Project	South Caldecotte		
Document Number	SCD-BWB-GEN-XX-RP-TR-006_TN	BWB Ref	NTS2682
Author	Ahmad Huneidi	Status	S2
Checked	Matthew Addison	Revision	P1
Approved	Matthew Addison	Date	05/02/2020

- 1.1 BWB Consulting Ltd (BWB) has been appointed by Hampton Brook (UK) Ltd (the Client) to prepare this response to Technical Note 06 (received 29th January 2020) produced by AECOM on behalf of Highways England in relation to the traffic impact of the proposals at South Caldecotte on the strategic road network (SRN).

RESPONSE TO TN06 TECHNICAL NOTE
South Caldecotte

Figure 33 Congestion hot spots – 2031 AM Peak link and junction v/c over 85%

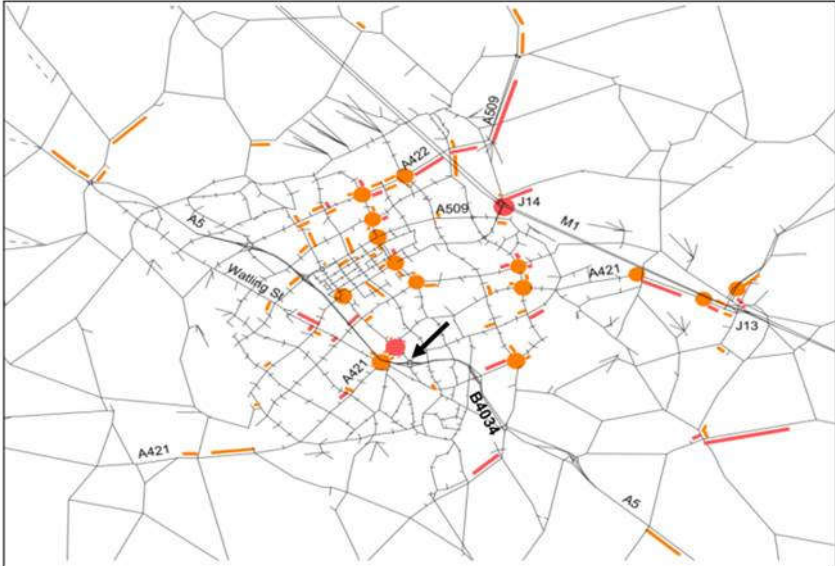
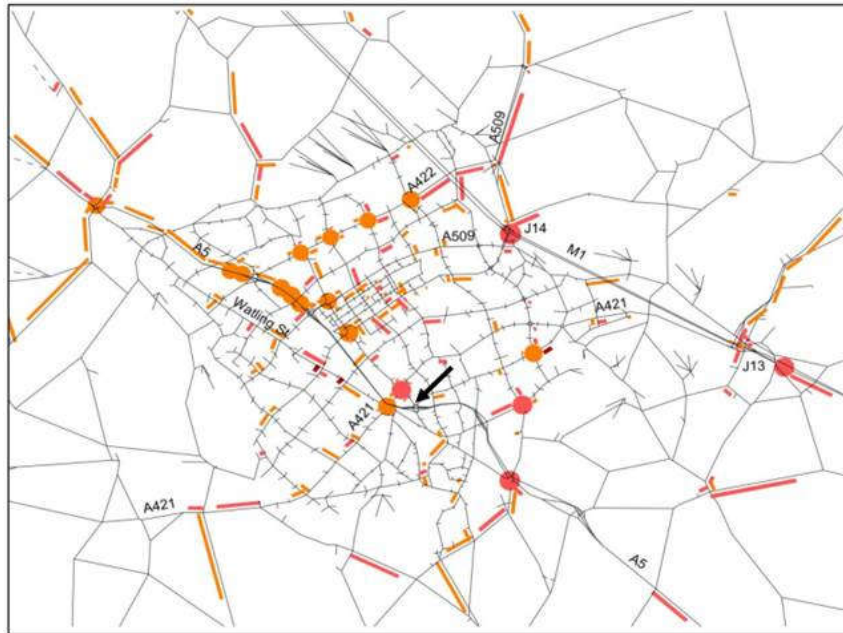
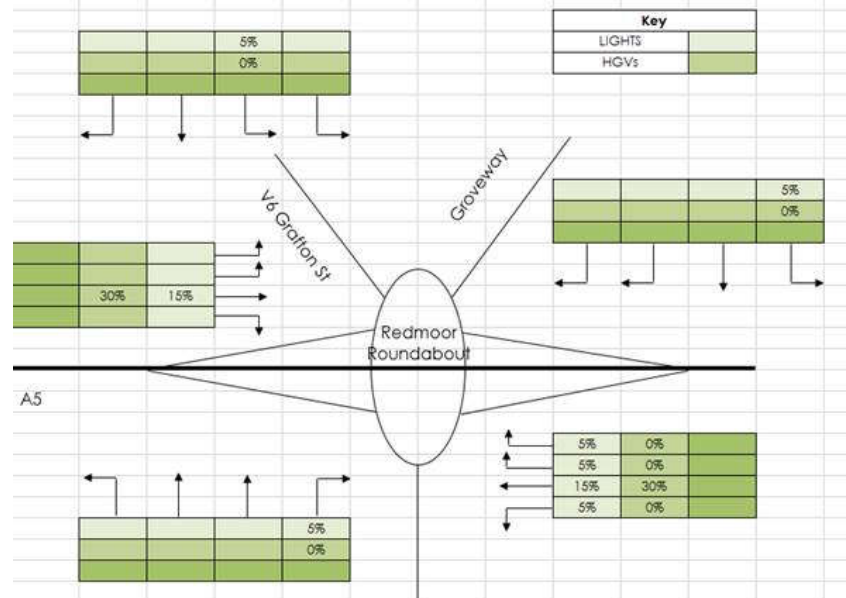
Rating	AECOM Recommendation	BWB Response
Critical	A capacity assessment should be undertaken at the A5 Redmoor junction.	<p>To provide context, the A5 Redmoor roundabout was included in the study area of the MK Multi Modal Model, the results of which are presented in Chapter 5 of Mobility Strategy for Milton Keynes 2018-36 (LTP4) Detailed Context and Evidence Base. Figure 24 (below) of the document highlights congestion hot spots in Milton Keynes in the 2016 AM base scenario and indicates that the A5 Redmoor roundabout operates with reserve capacity.</p> <p style="text-align: center;">Figure 24 Congestion hot spots – 2016 Base AM Peak link and junction w/c over 85%</p>  <p>Figure 33 of the Evidence Base shows the same network in 2031 and again indicates that the junction in question would operate with reserve capacity.</p>
